Proposed Revisions to a Standard Plans Index

Index Number: 455-060
Sheet Number (s): 1
Index Title: 60" Prestressed Concrete Cylinder Pile

Summary of the changes:

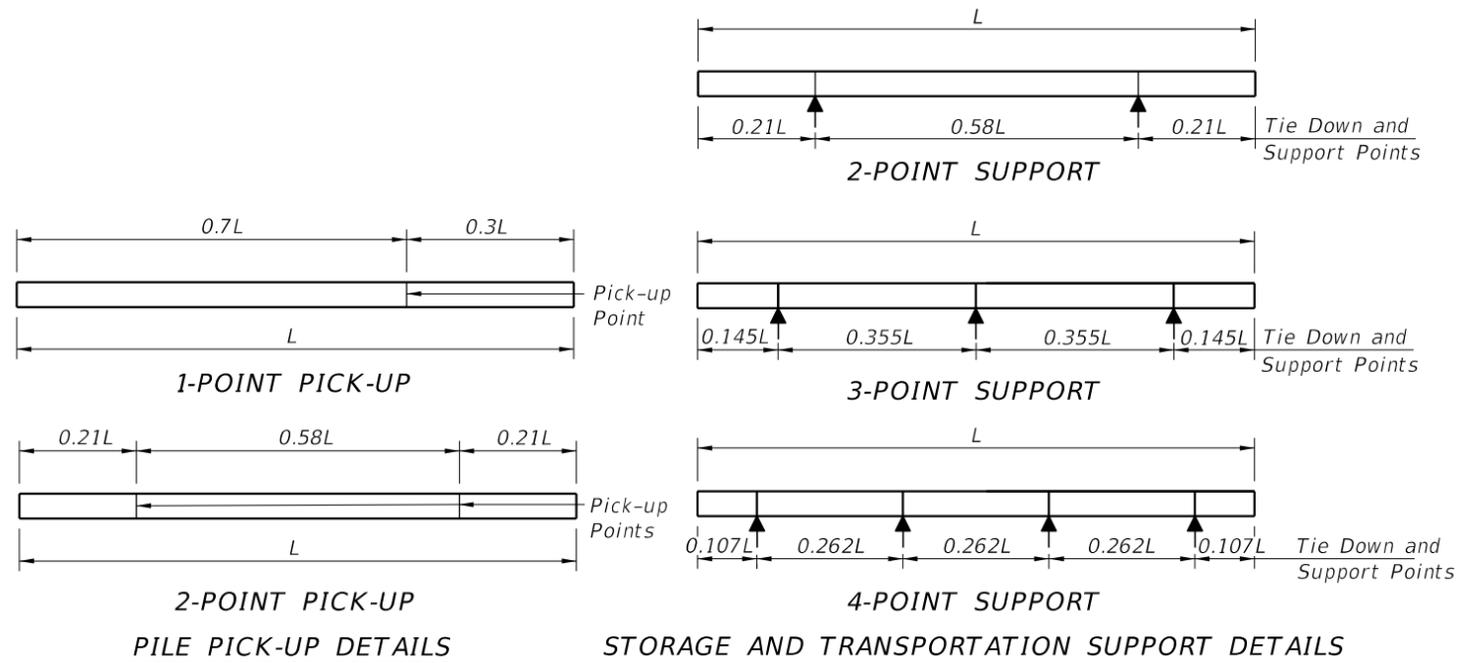
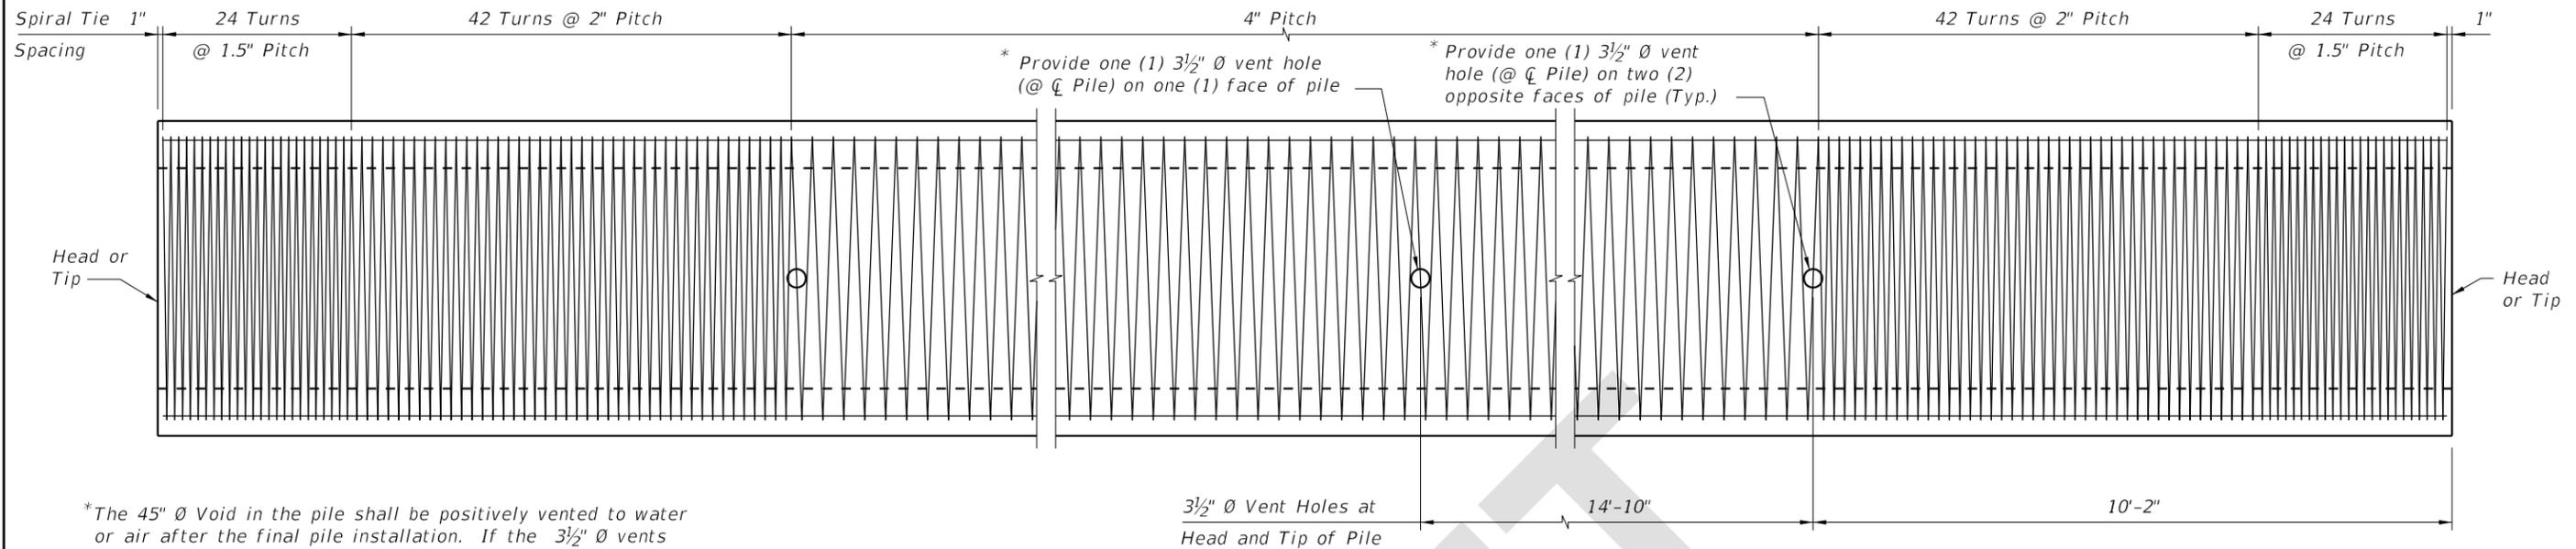
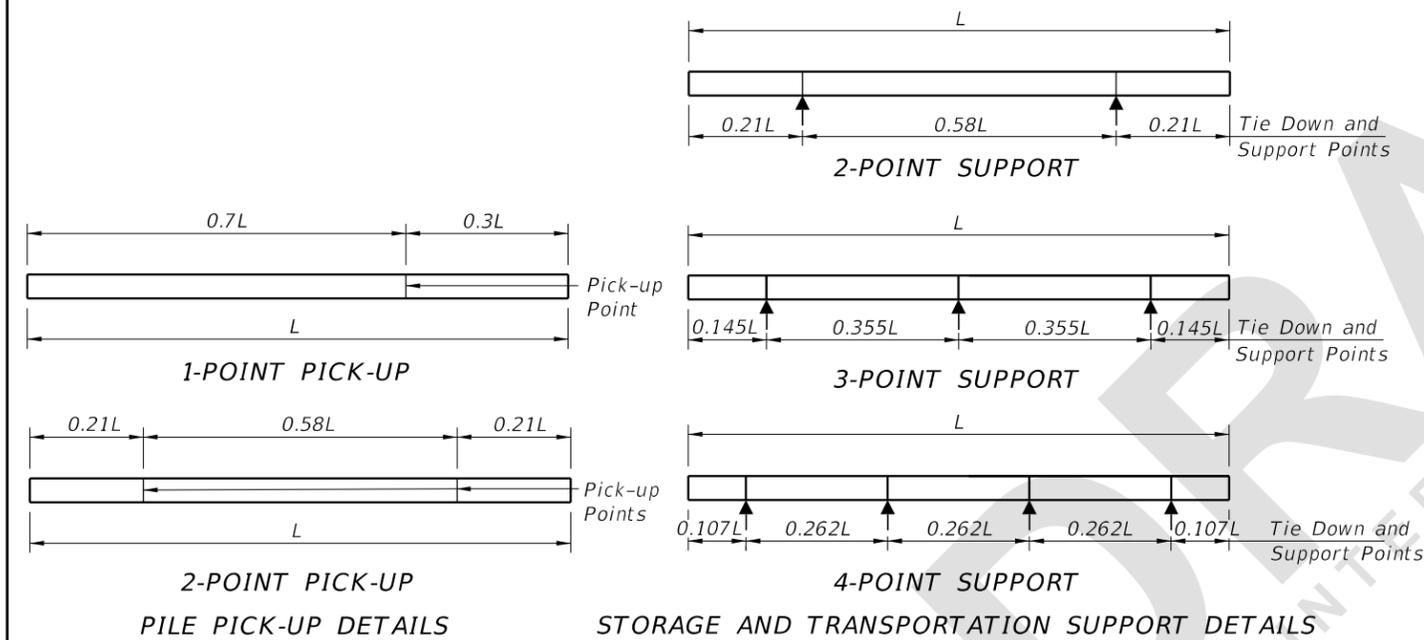
Changed Class V (Special) concrete to Class V.

- Work this Index with the Pile Data Table in the Structures Plans.
- Concrete:
 - Piles: Class V (~~Special~~)
 - Splice Collar: Class IV
 - See "GENERAL NOTES" in the Structures Plans for locations where the use of Highly Reactive Pozzolans is required.

- Work this Index with the Pile Data Table in the Structures Plans.
- Concrete:
 - Piles: Class V
 - Splice Collar: Class IV
 - See "GENERAL NOTES" in the Structures Plans for locations where the use of Highly Reactive Pozzolans is required.
